## U.S. ENVIRONMENTAL PROTECTION AGENCY, REGION 2

Re: Re: Lower Passaic River Study Area Revision 2 Draft Baseline Ecological Risk Assessment  
(Agreement) CERCLA Docket No. 02-2007-2009

**EPA COMMENTS – JULY 10, 2018**  
**LPRSA Revision 2 Draft BERA - Dated December 29, 2017**

Figure 1. How restricted range of predictor variable influences  $R^2$ .

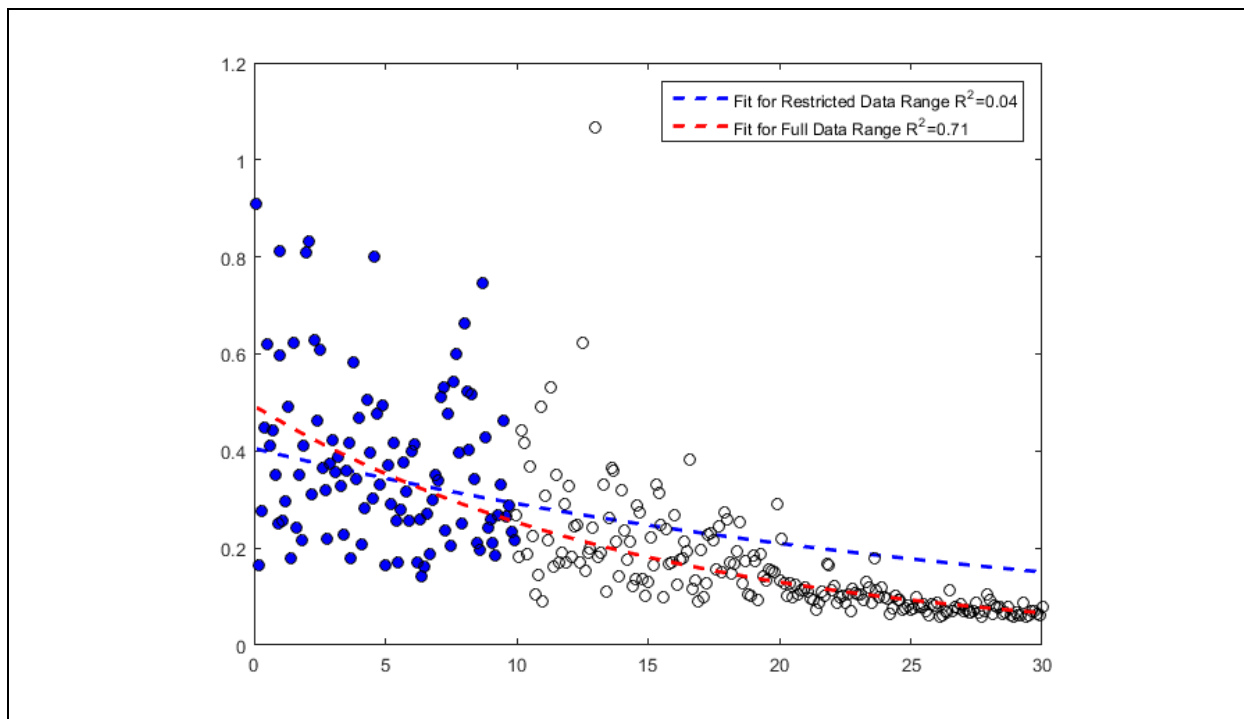
Although commonly reported as a traditional measure of model quality, it is well known that  $R^2$  values are generally not indicative of model utility. Low  $R^2$  values are not necessarily an indicator of a weak relationship, and high  $R^2$  values are not necessarily indicative of a correct model (for an excellent synopsis and multiple references, see Section 3 of the following lecture notes: <http://www.stat.cmu.edu/~cshalizi/mreg/15/lectures/10/lecture-10.pdf>).

Figure 1 (below) illustrates one of these problems with using  $R^2$  as an absolute indicator of model utility, when models are fit to data with a narrow range in the predictor. In the figure, one set of data were simulated from a Gompertz survival function and models were fit first to a restricted subset of the data shown as blue circles, yielding  $R^2 = 0.04$ . The second model was fit to the entire data set resulting in a dramatically higher  $R^2 = 0.71$ , despite the same model being fit to the data. Both fitted models provide a reasonable fit to the blue data points. The blue line surprisingly provides a reasonable extrapolation beyond the range of blue points. Treating  $R^2$  as an absolute indicator of model utility, as was done in the BERA, would suggest largely dismissing the association between survival and contaminant concentrations as represented by the factor scores.

Figure 2. Non-normally distributed survival data (top panel) with heteroskedastic variances (lower panel).

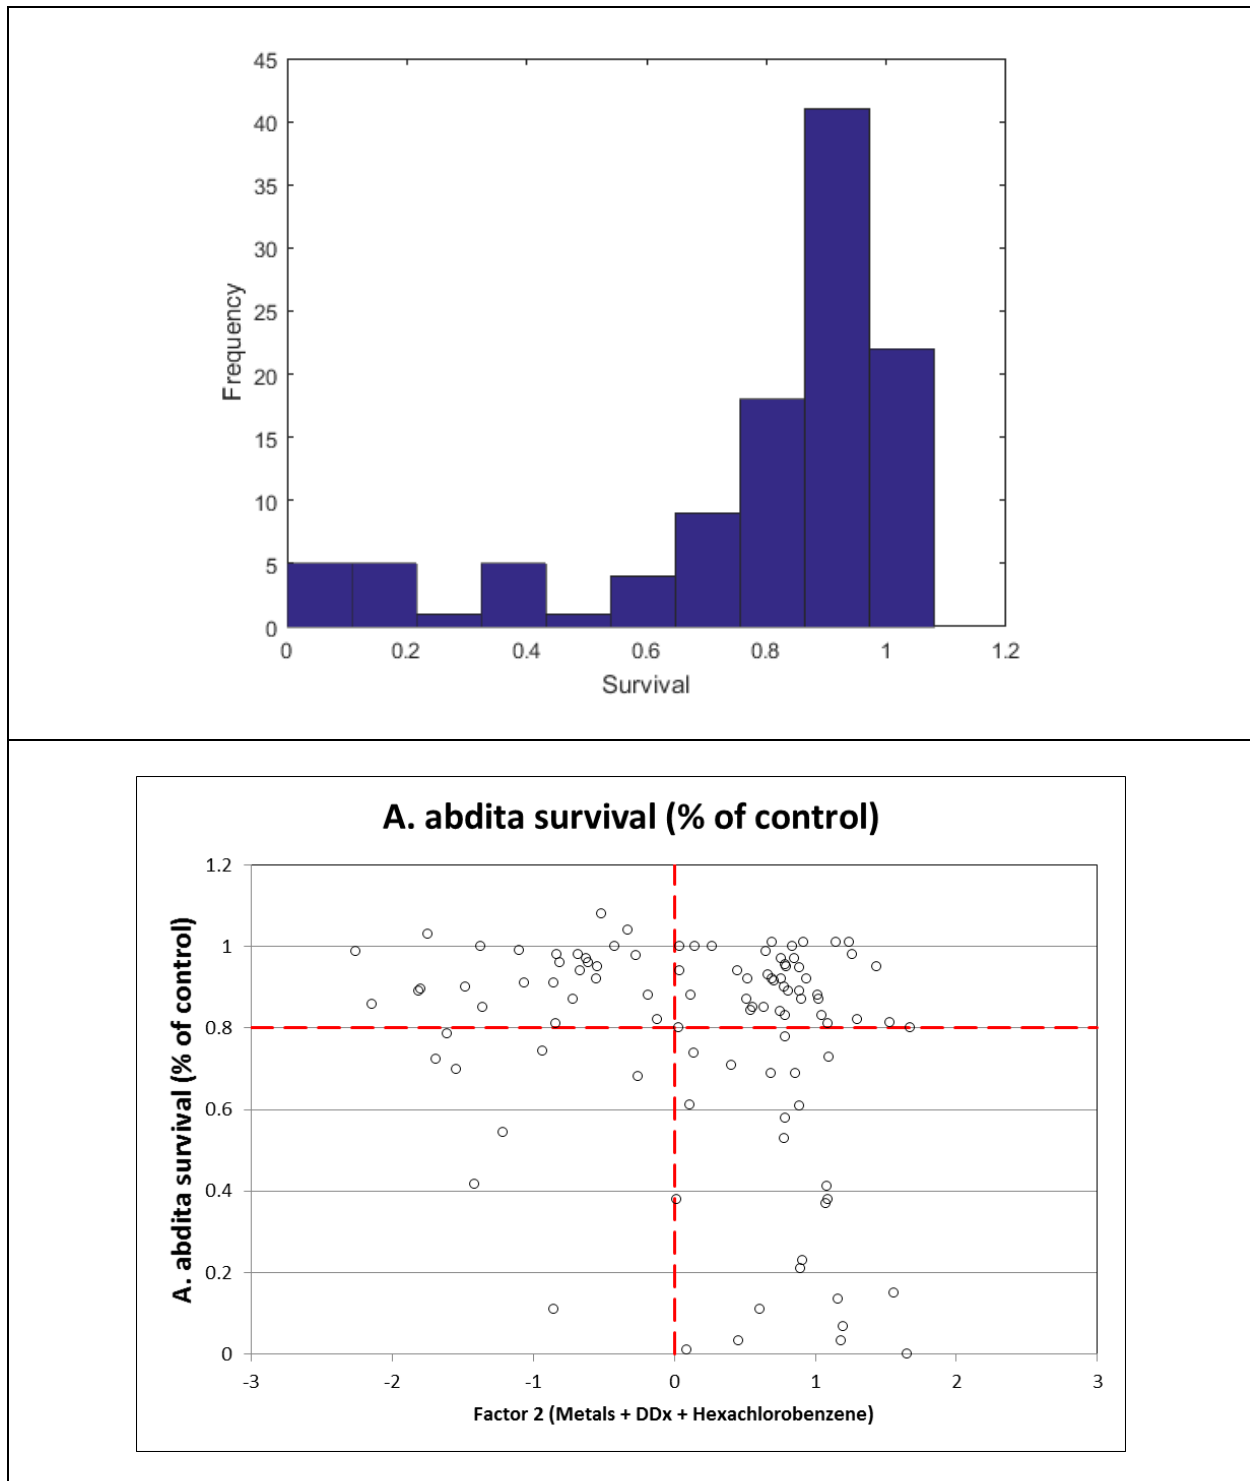
The sampling variance of a proportion is a function of the proportion itself. The Figure 2 (below) plot of *Ampelisca abdita* survival against Factor 2 scores<sup>1</sup> (metals and DDx and hexachlorobenzene) shows data that are highly non-normal (top panel) and heteroskedastic (bottom panel). Due to these deviations from assumptions for a linear fit, the low  $R^2$  for a linear function fit to these nonlinear data is expected. The low  $R^2$  in this case reflects the mismatch between the data and fitted model more than information about the relationship between chemical concentrations and biological effects.

The upper panel in Figure 2 (below) shows that the survival data are highly left skewed, with most toxicity tests yielding values greater than 60% (which in and of itself is important information). Noting that few tests resulted in data with high mortality indicates that estimated associations are likely to be imprecise, due to a lack of variation along the concentration gradient. This suggests that the range of sediment contamination levels evaluated was too narrow to precisely quantify the relationship between COPC concentrations and survival.

The lower panel of Figure 2 (above) also provides important information regarding the nature of the relationship between *A. abdita* survival and Factor 2 (metals and DDx and hexachlorobenzene). The BERA fits a linear model to the data, effectively trying to fit a straight line to the data. It is clear that such a best fit line would only crudely describe the relationship. This plot shows that the proportion of tests exceeding 80% of control is high at the low end of the Factor 2 scale (when metals and DDx and hexachlorobenzene are low) and that for higher levels of Factor 2, the percentage of tests exceeding 80% of control declines. A higher proportion of test results are below the 80% level when the Factor 2 is high. With this increase in Factor 2, the variance of the data also increases with test results ranging from essentially zero survival to 100% of control. Whereas, when Factor 2 is low, virtually all tests resulted in survival greater than 80% of control. This is a highly nonlinear relationship with strongly heteroskedastic errors. The BERA needs to include a discussion of this to illustrate the nature of the relationships that were found and how their nonlinear form tends to reduce measures of model fit, despite obvious underlying relationships establishing associations between biotic metrics and chemical concentrations. Fitting the wrong model (in this case, linear) and then pointing out a low  $R^2$  does not mean there is no relationship. The main conclusion is that the analysis in hand shows that negative effects are associated with chemical stressors. Poor fit for a linear regression is not indicative of the nature of these relationships and should be de-emphasized, in favor of more extensive discussion of the nature of the relationships themselves.

### Figure 3: Factor 2 Loadings

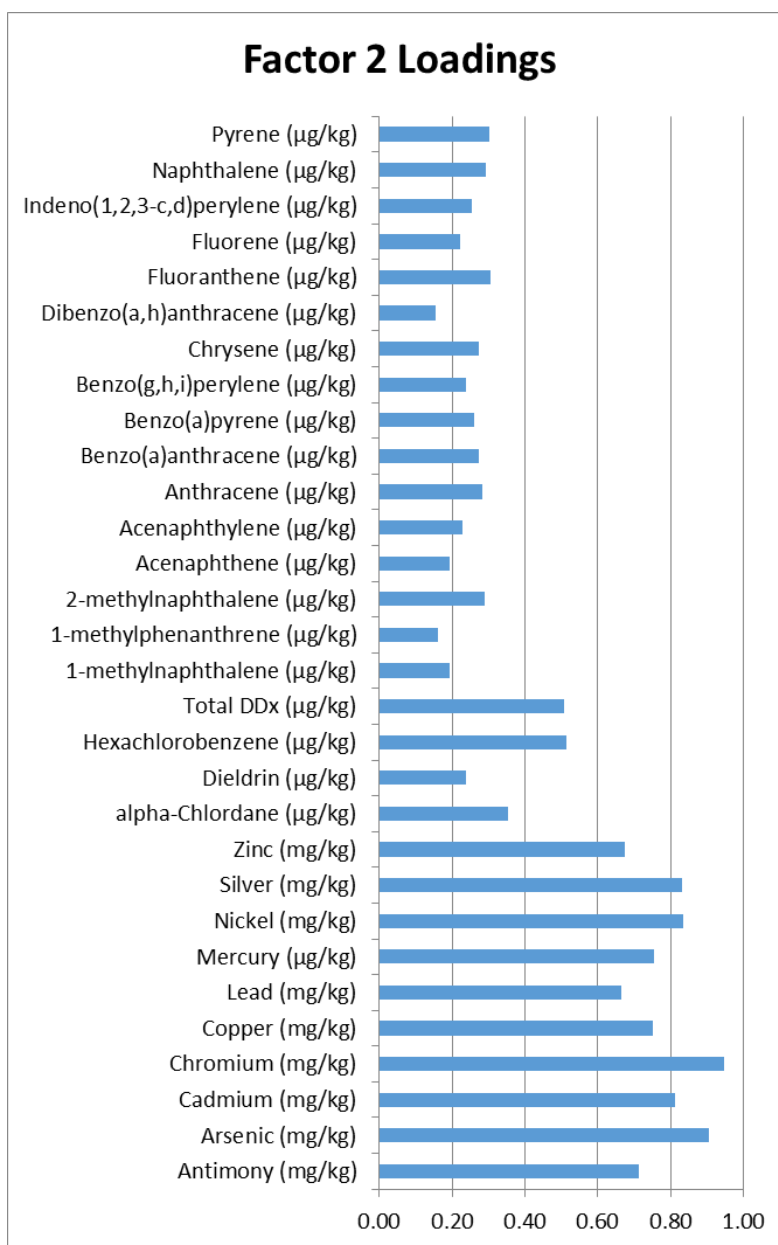
The report also fails to adequately discuss and display the factor loadings that were derived from the analyses. With the emphasis on downplaying the importance of the findings, it seems a detailed description of the factor analysis results was omitted. The tabulations provided in spreadsheets form the basis of what needs to be more fully illustrated with figures, and thoroughly discussed in the text. One strength of the exploratory factor analysis (EFA) approach is that results lend themselves to graphical displays to communicate results. The BERA should develop a complete set of figures depicting factor loadings, along with maps of factor scores to illustrate the results (to effectively develop maps to show where the combined concentrations of contaminants are high enough to potentially induce biological effects).

In particular, the EFA provides important information related to risk management options that will become important in the Feasibility Study (FS). For example, the plot in Figure 3 (below) shows that metals contamination, DDx, and hexachlorobenzene tend to be strongly correlated, indicating that they are likely co-located spatially. This information, if verified through careful evaluation, could lead to streamlined selection of preliminary remedial goals (PRGs) on the basis that goals set for one metal (or DDx, or hexachlorobenzene) may also serve to capture other variables that tend to be associated with a single “sentinel” contaminant. Conversely, efforts to identify a single contaminant or a small number of contaminants responsible for effects on benthic invertebrates are unlikely to be successful due to the
